C O N V A I R

COMMERCIAL CHANGE PROPOSAL

SPEC NO.: ZD- 22-002

CUSTOMER: Hughes Tool Company

Enclosure: (A) One copy of sketch - GASEOUS OXYGEN SYSTEM
(for preliminary use only, Figure 3.19-4 will
be revised to reflect the above change)

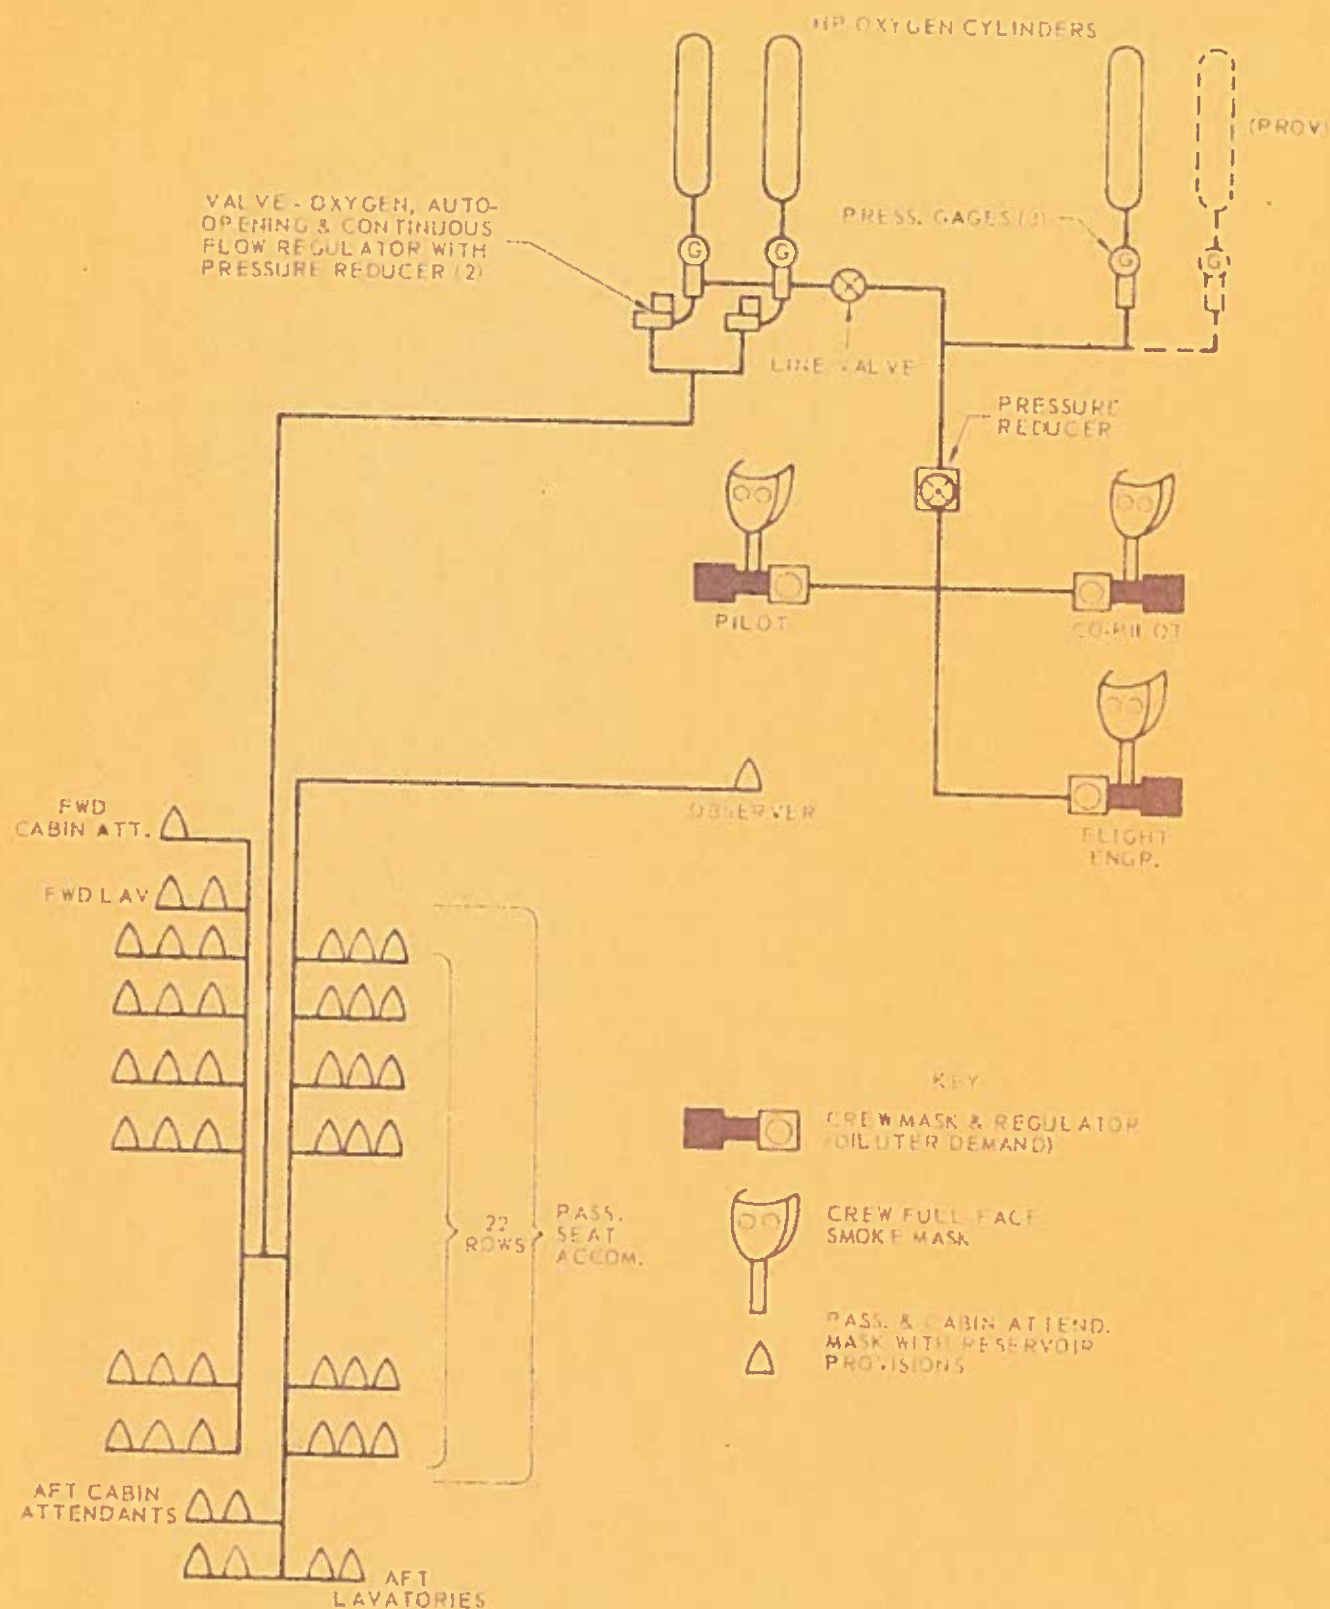
Page 118, Paragraph 3.19.5.4 INDIVIDUAL OUTLETS:

Change the third sentence to read as follows:

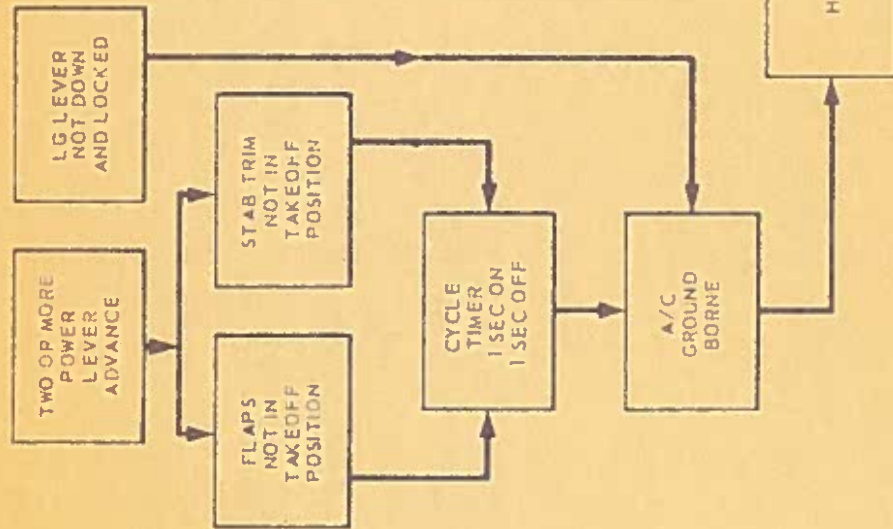
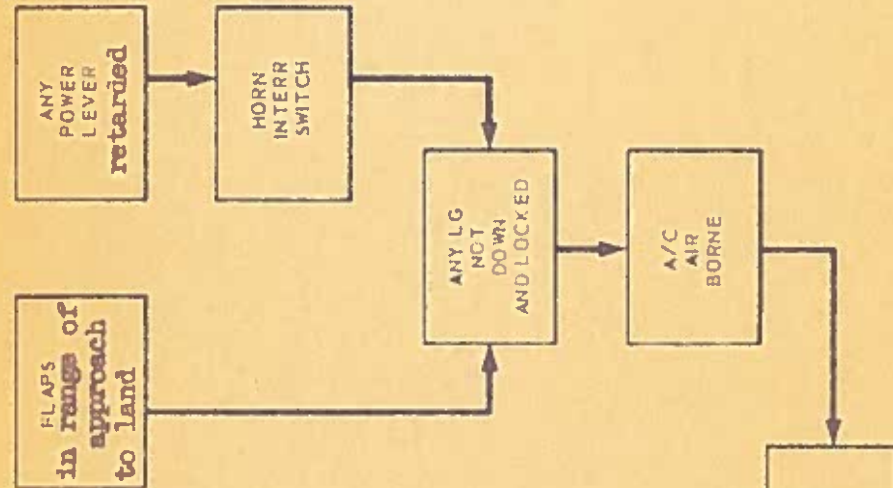
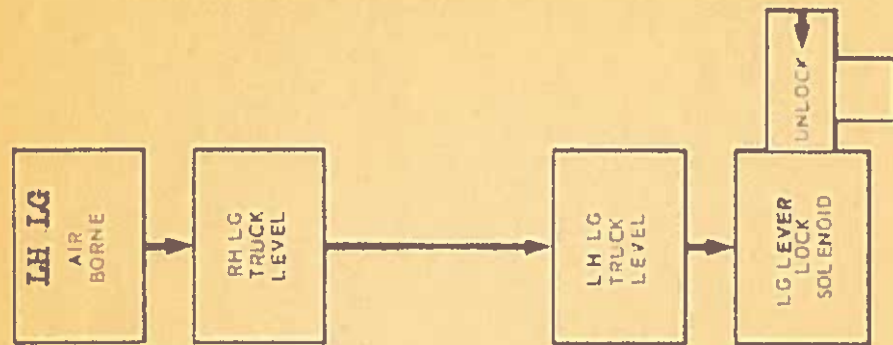
Revise the paragraph title and paragraph to read as follows:

"LANDING GEAR AND STABILIZER WARNING HORN: A horn shall be provided to operate under the following conditions:

When any landing gear is not fully extended and locked with the aircraft airborne, the horn will operate if any power lever is retarded or if the flaps are in the range of approach to land. The power lever retard function will have a horn interrupter switch.

When the aircraft is ground borne, the horn will operate if the landing gear override lever is moved.

When the airplane is on the ground and any two or more of the power levers are advanced to take-off position, the horn will operate if the stabilizer and/or the flaps are not in the correct takeoff position.

C.O. & M.A.C.
C.G. DESIGN LIMITS

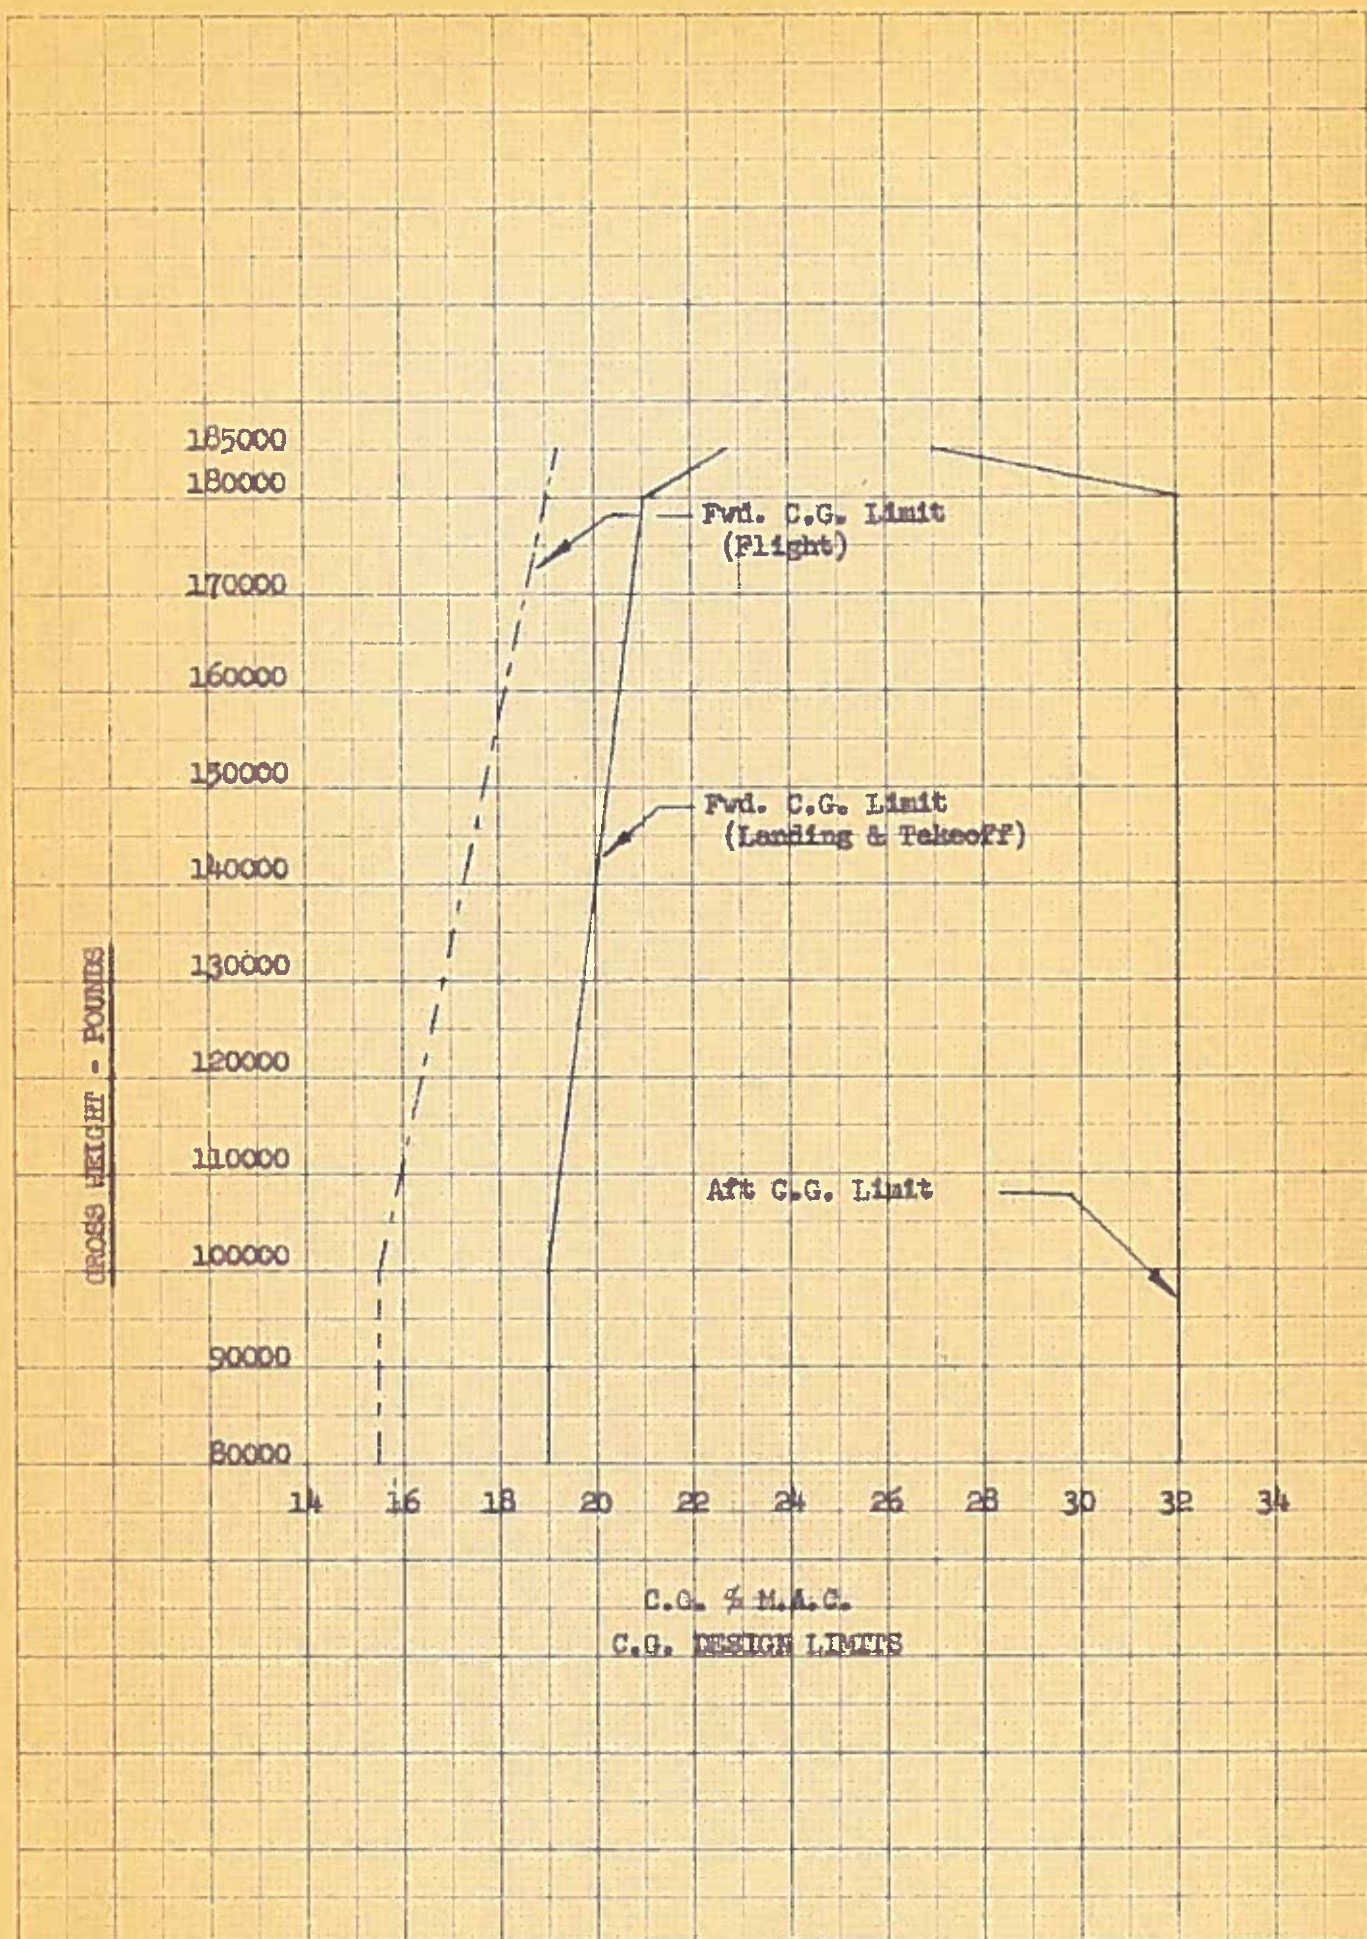
"Weight increase of 84 lbs is based on C. G. limits shown on Enclosure (A). If the airplane is operated at gross weight above 180,000 lbs, with center of gravity location outside of the indicated limits, heavier tires and main landing gear will be required."

Enclosure: (A) One (1) copy of sketch on proposed position light
locations (for information only).

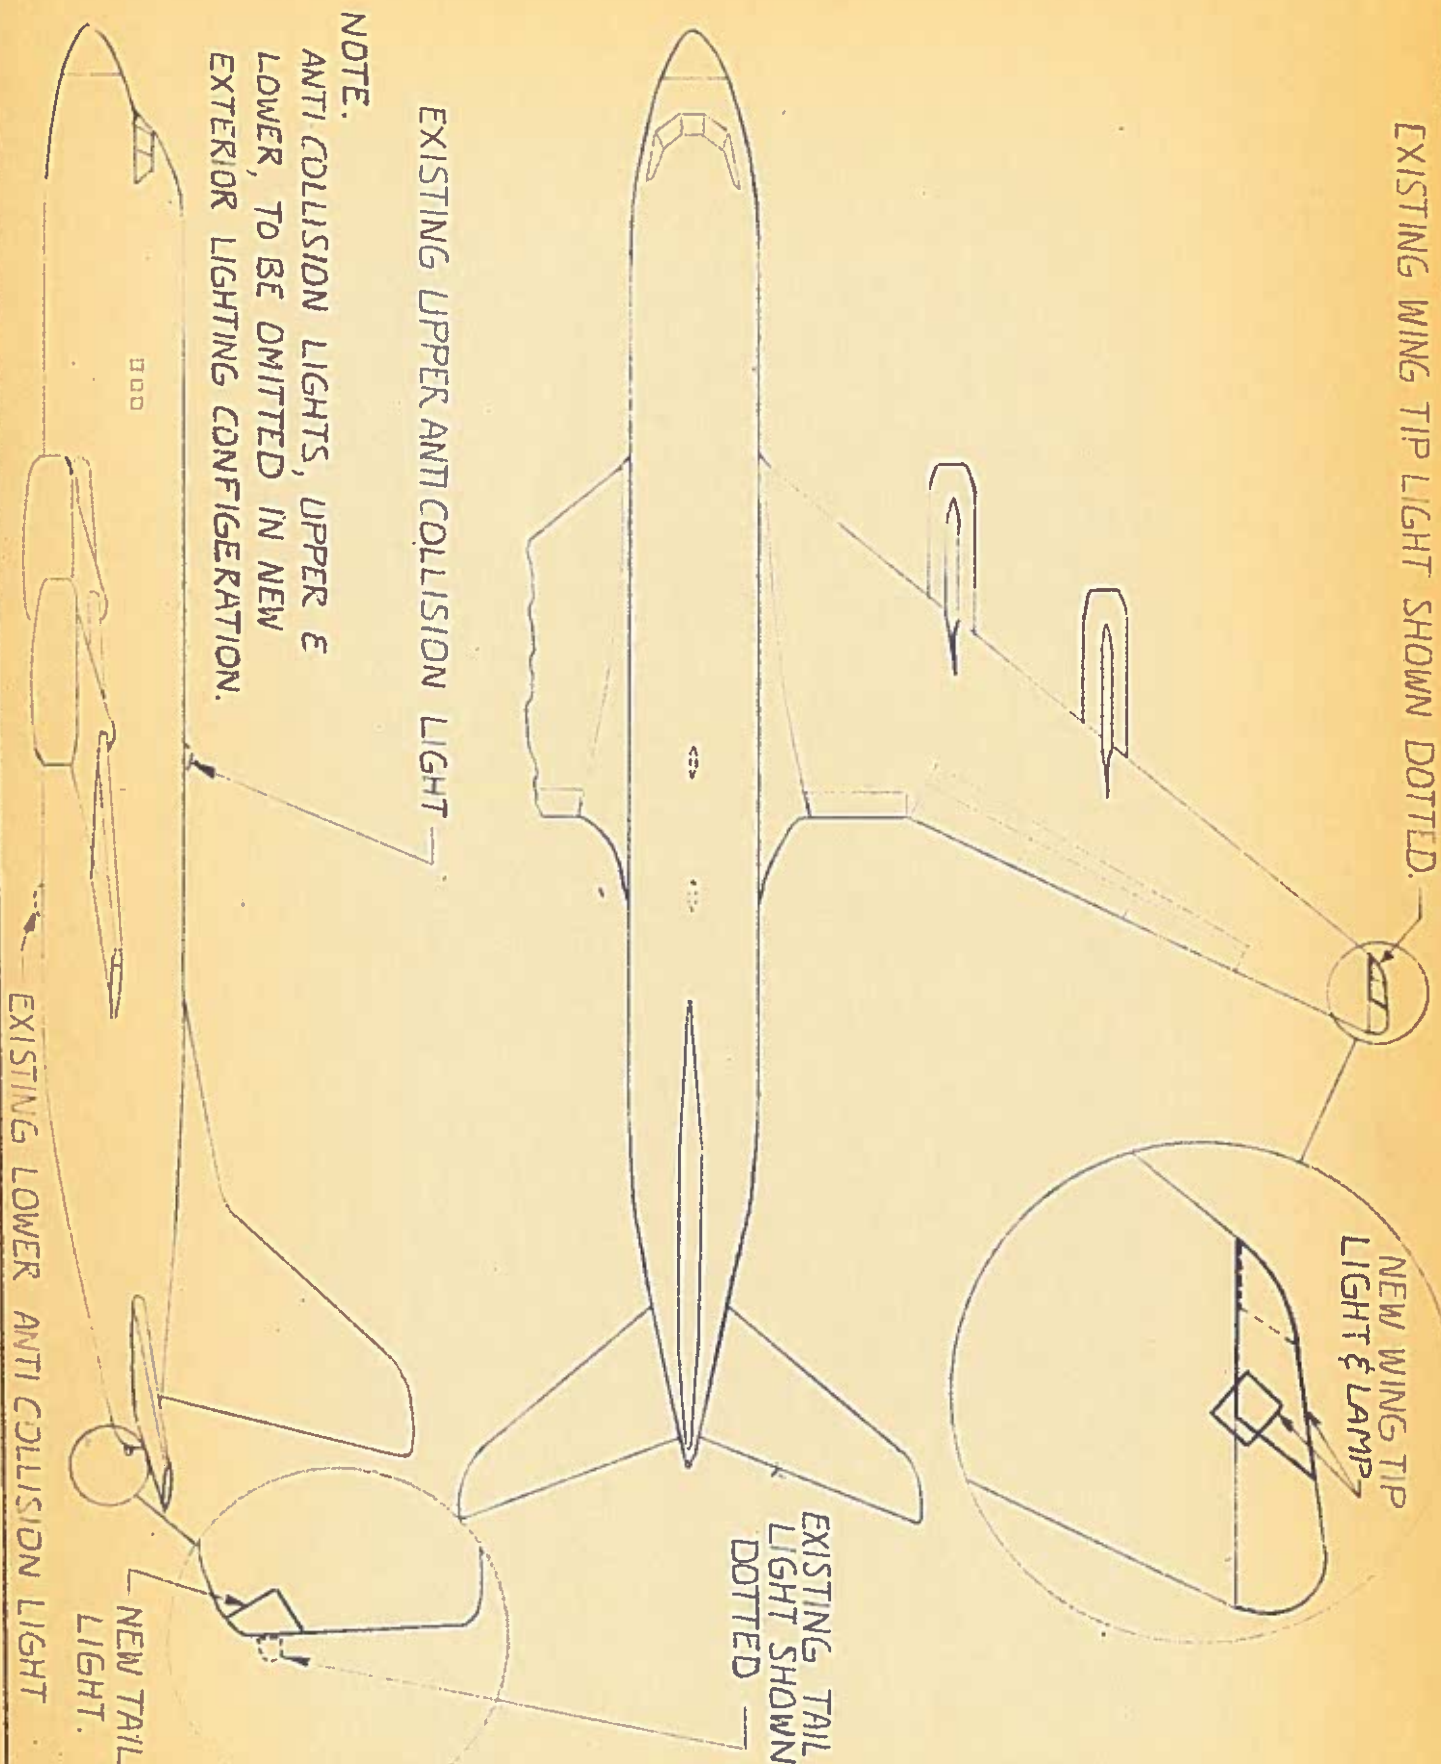
From: "1 Tail Position Light, Grimes B7890-1-311"

To: "1 Position Light Assembly, Aft, Oscillating, White"

12-PLACE CLUB AREA

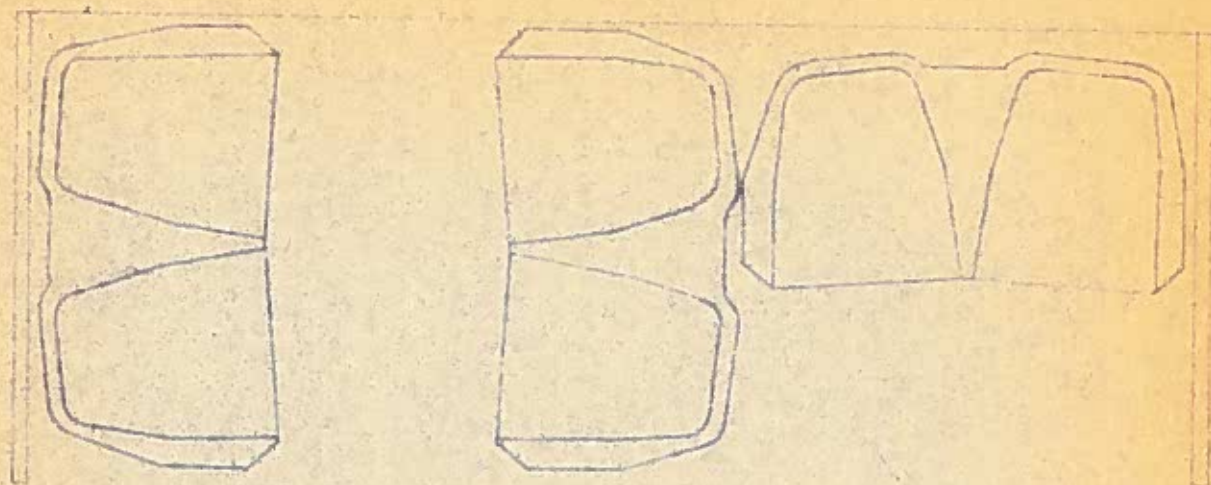
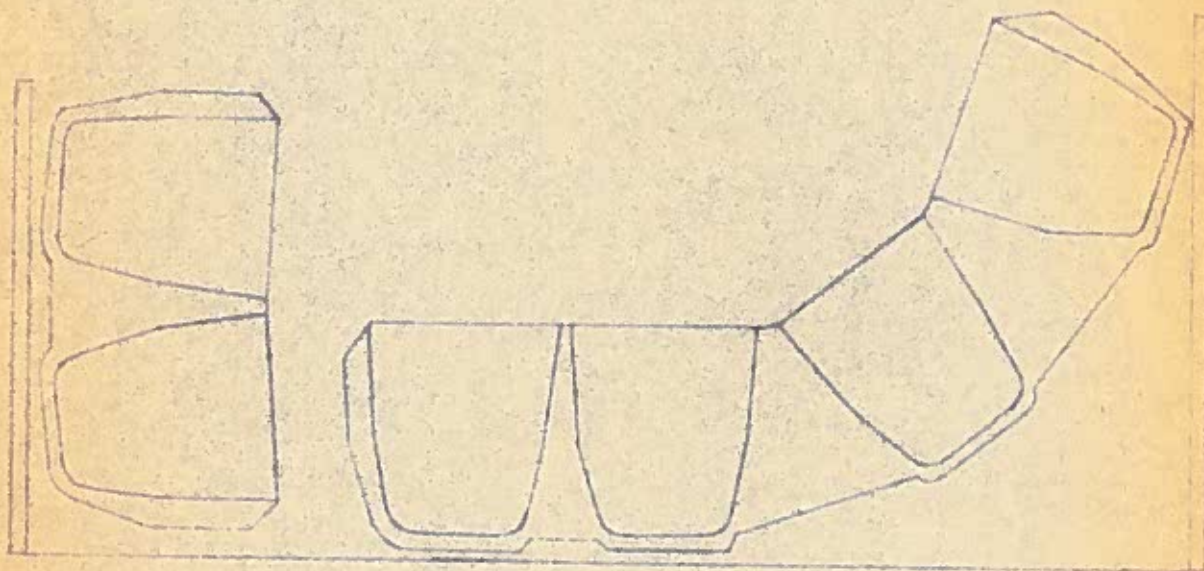
Enclosure: (A) One (1) copy of sketch of proposed Club Area Arrangement

AIRLINE SCHEDULE HOLDER

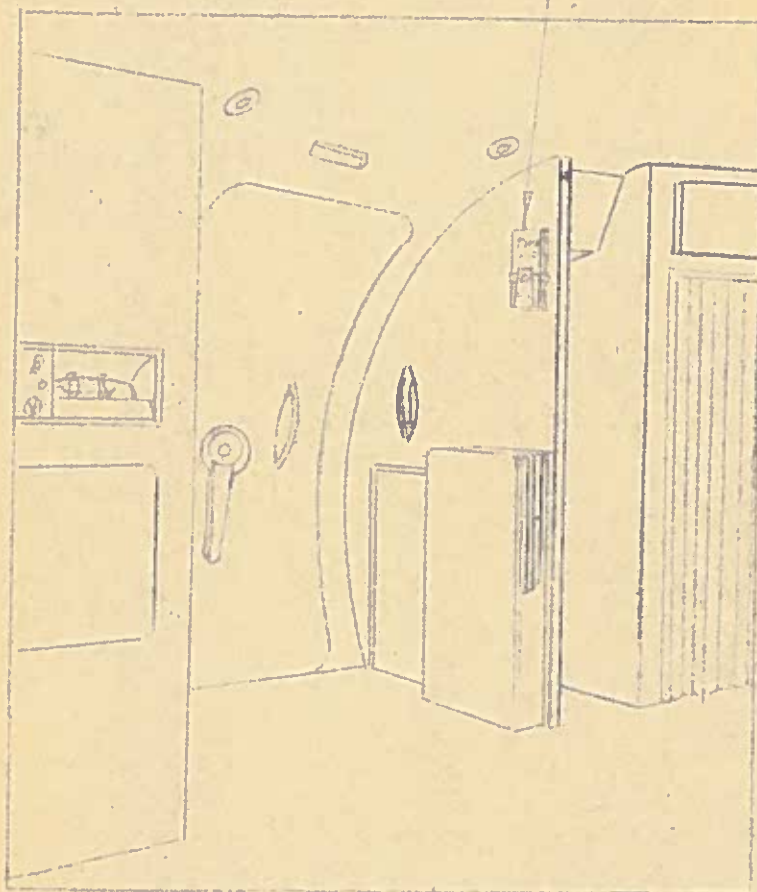
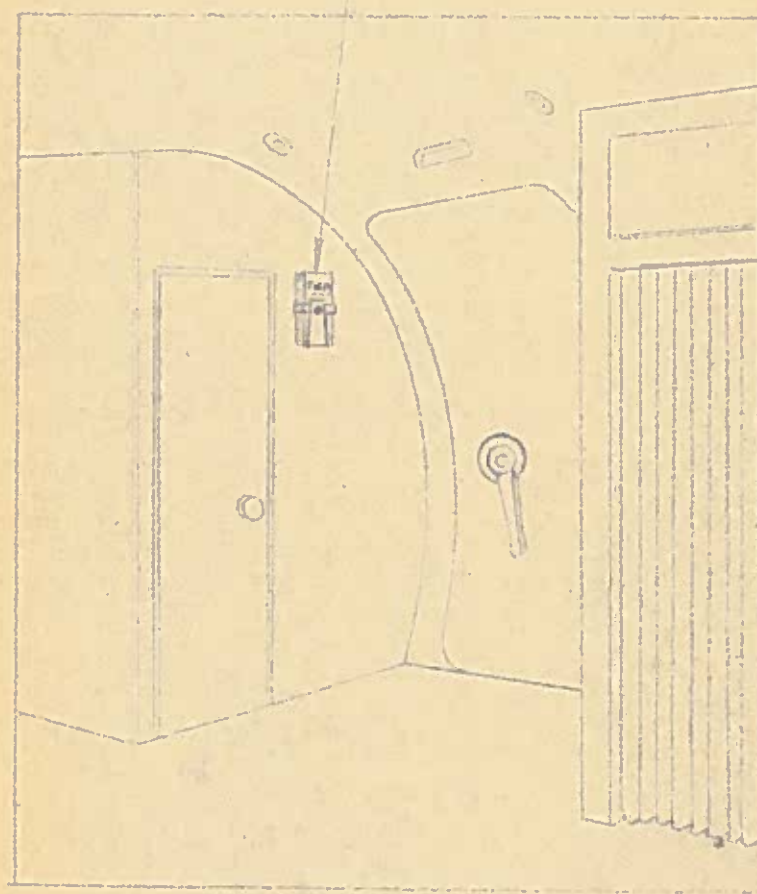
Page 114, Add the following new paragraph to the page after paragraph 3.19.3.6:
